ADDENDUM ONE

Project: **Sullivan County Immunization**

November 11, 2022

This Addendum is part of the Contract Documents for the above referenced project and modifies the original drawings and/or specifications, dated **10/27/22**, as noted below. The bidder shall acknowledge receipt of this Addendum in the place provided in the Bid Form. The published bid date and time shall remain the same.

SITE DETAILS

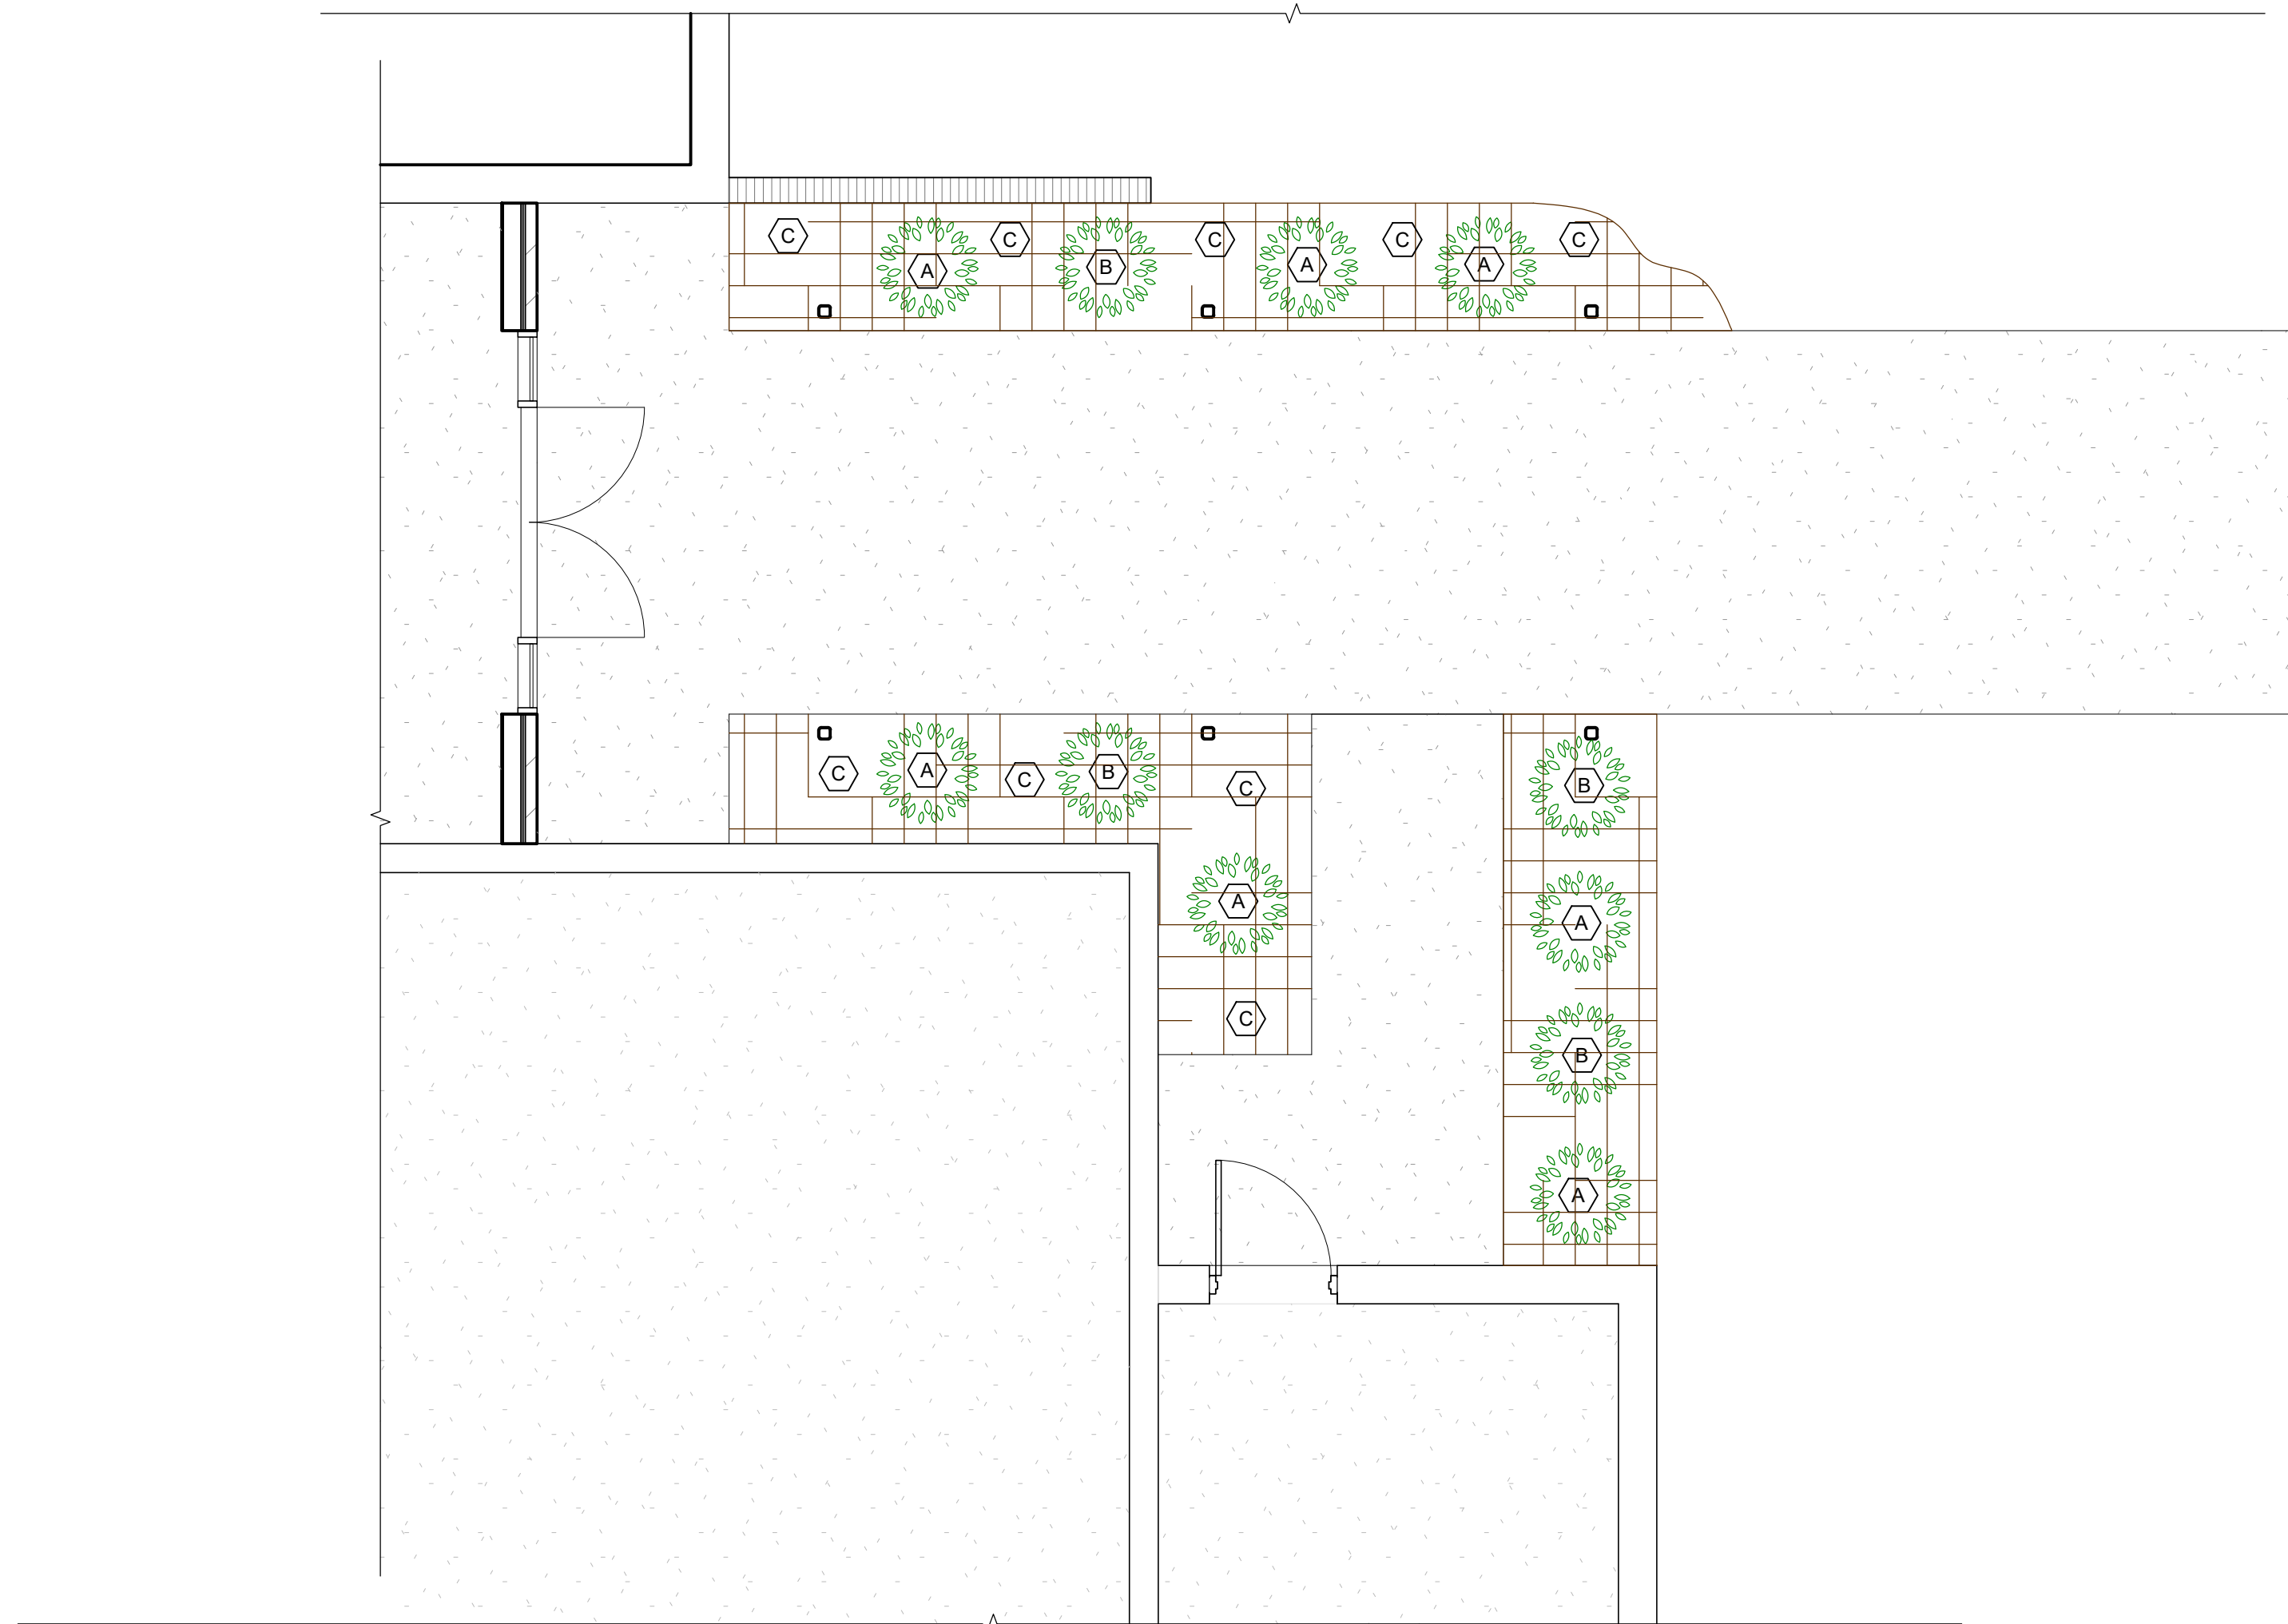
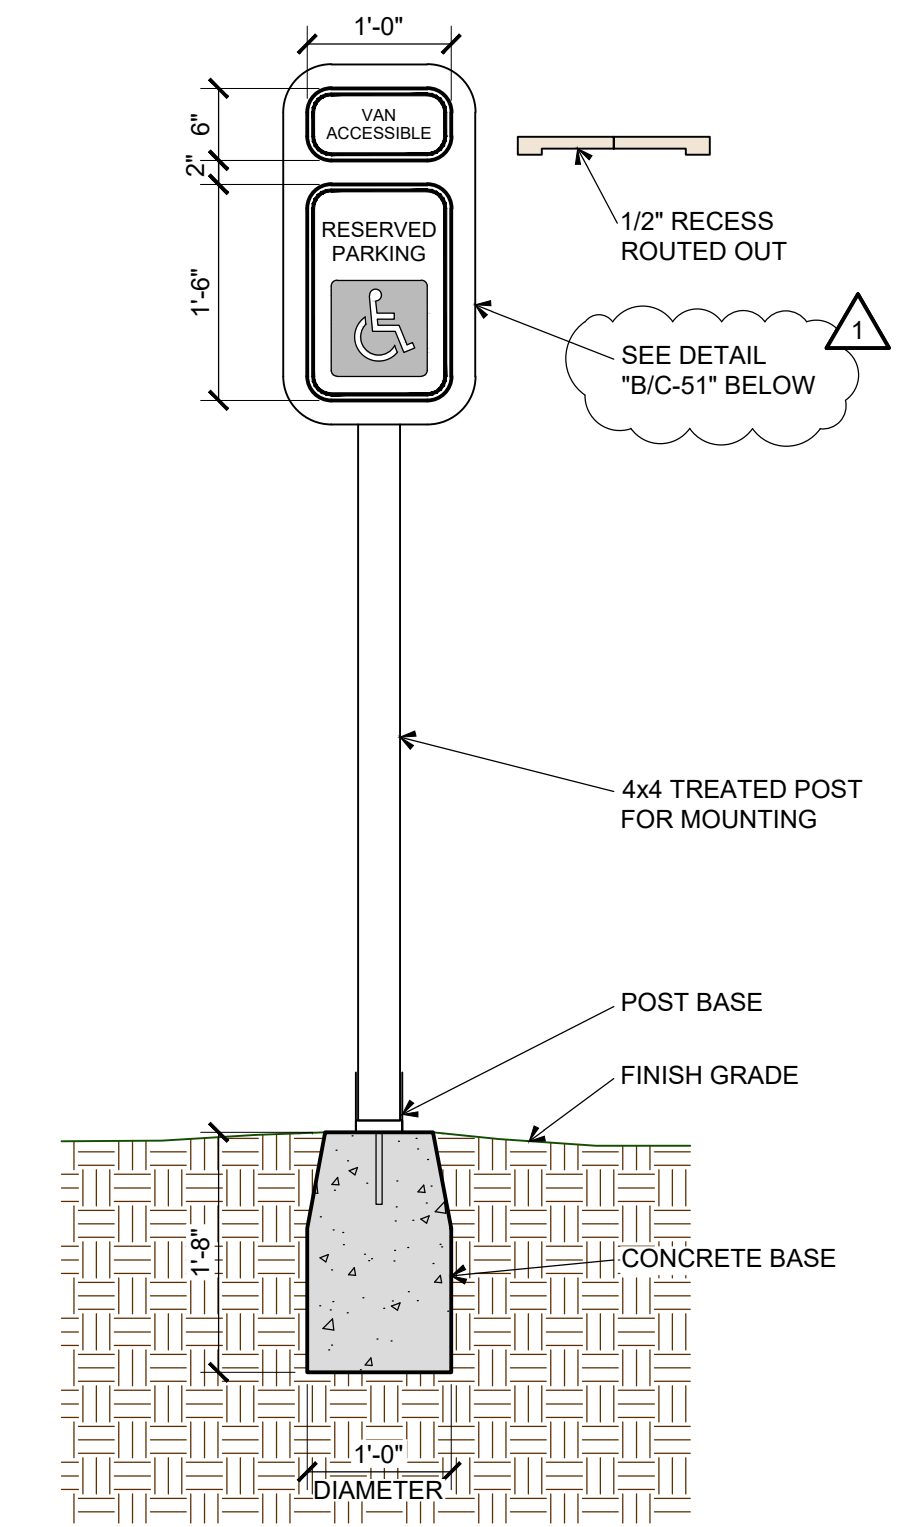
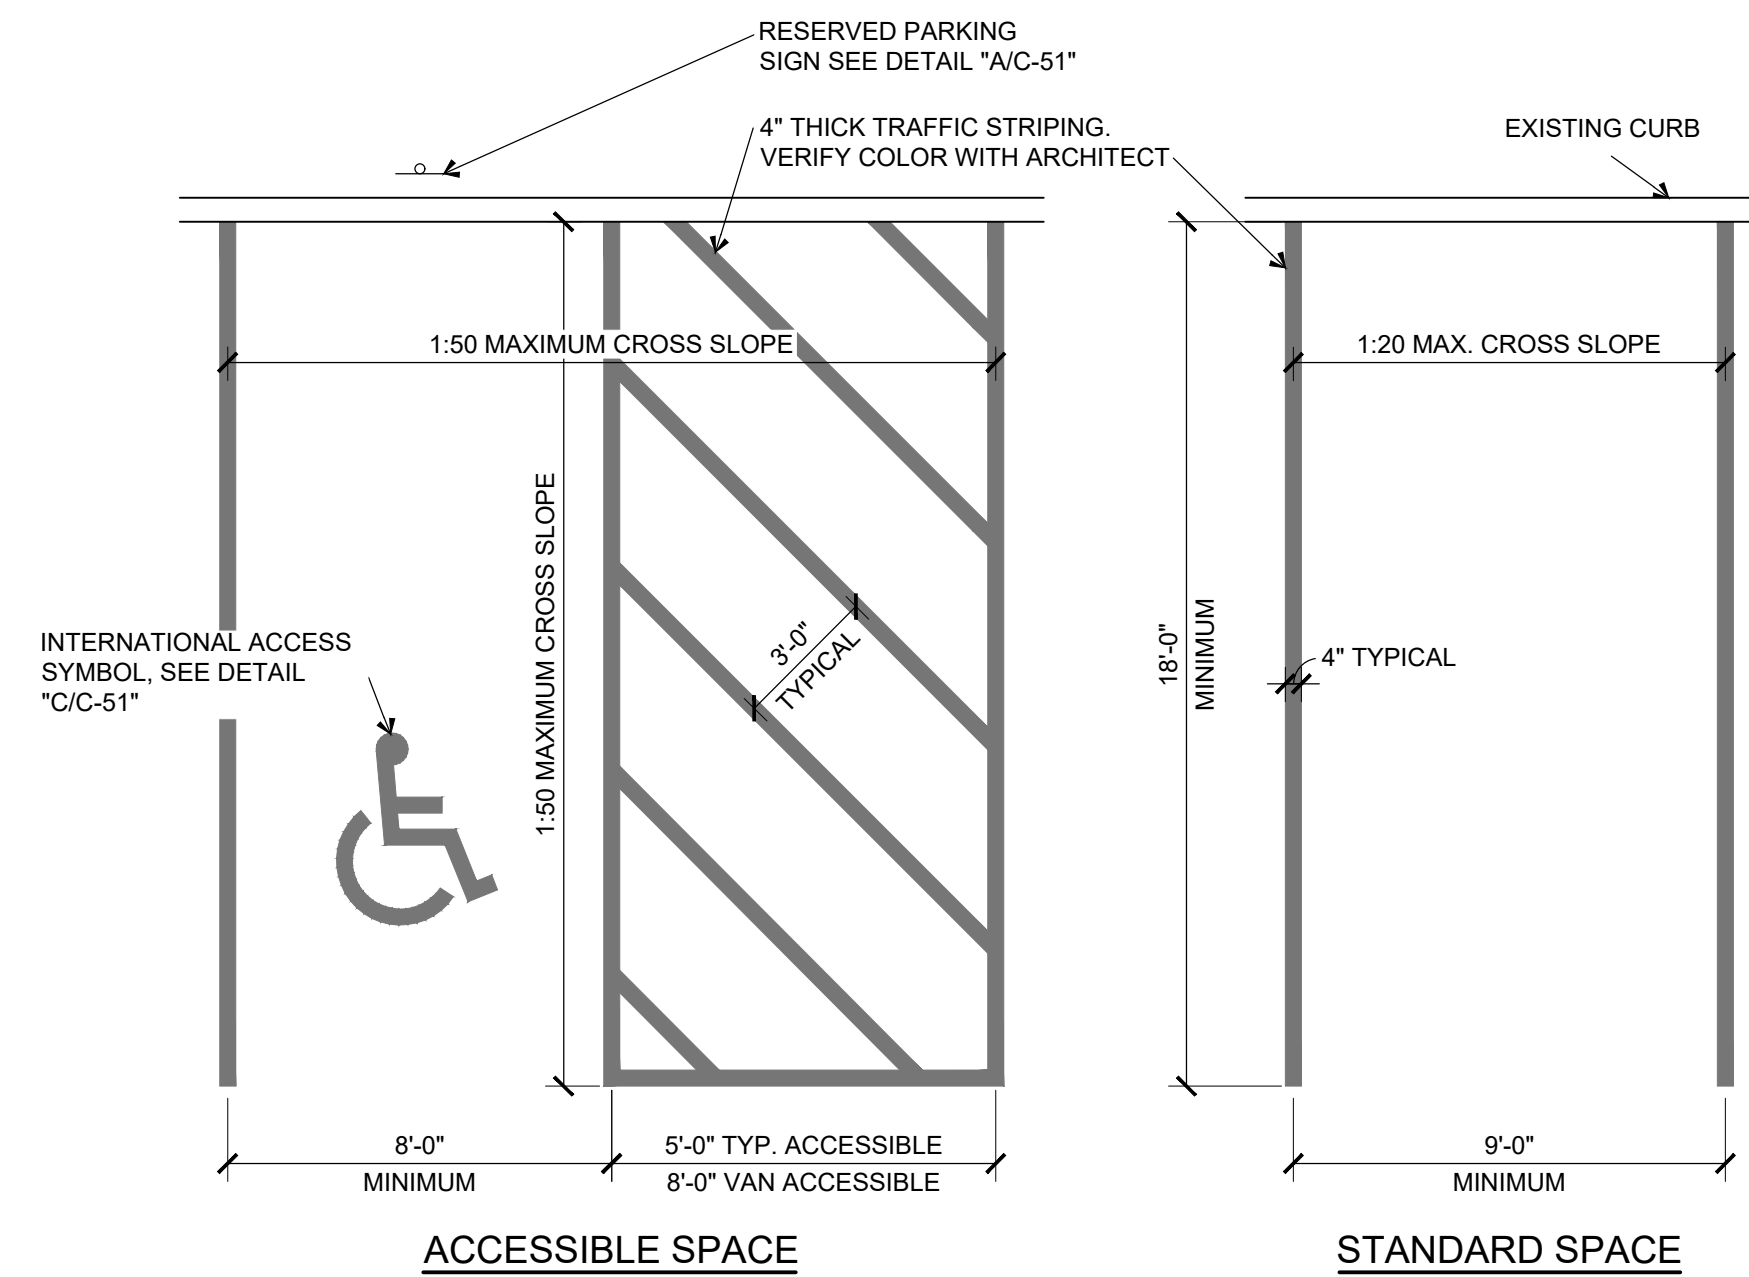
4. **Sheet C-51 Site Details** – clarification of notes.
5. **Sheet L-11 Landscape Plan** – change note 6.
6. **Sheet S-11 Foundation Plan** – add turn down slab detail.
